## Product Advisory

Issue Date: 13-November-2023

Tray changes for BCM54214 & BCM54216

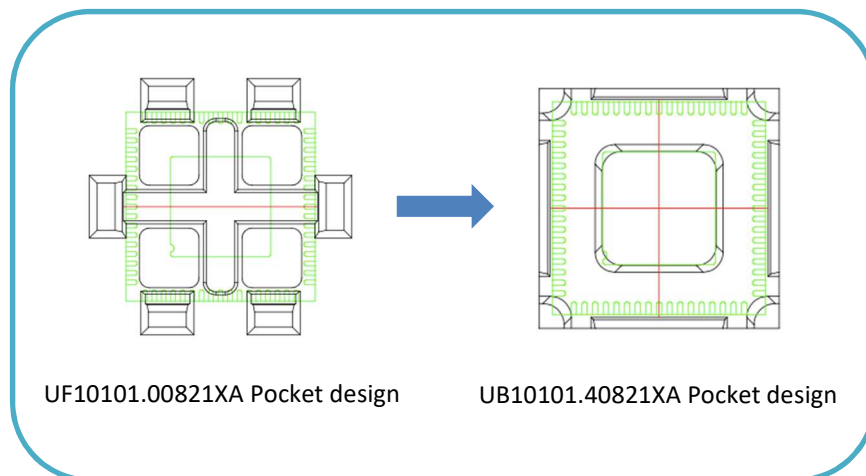
Change from Ubot UF10101.00821XA to Ubot UB10101.40821XA

Same Pitch: M=11.95, M3=16.00, M1=11.00, M2=14.65

Same Matrix: 8x21

Tray pocket design change:
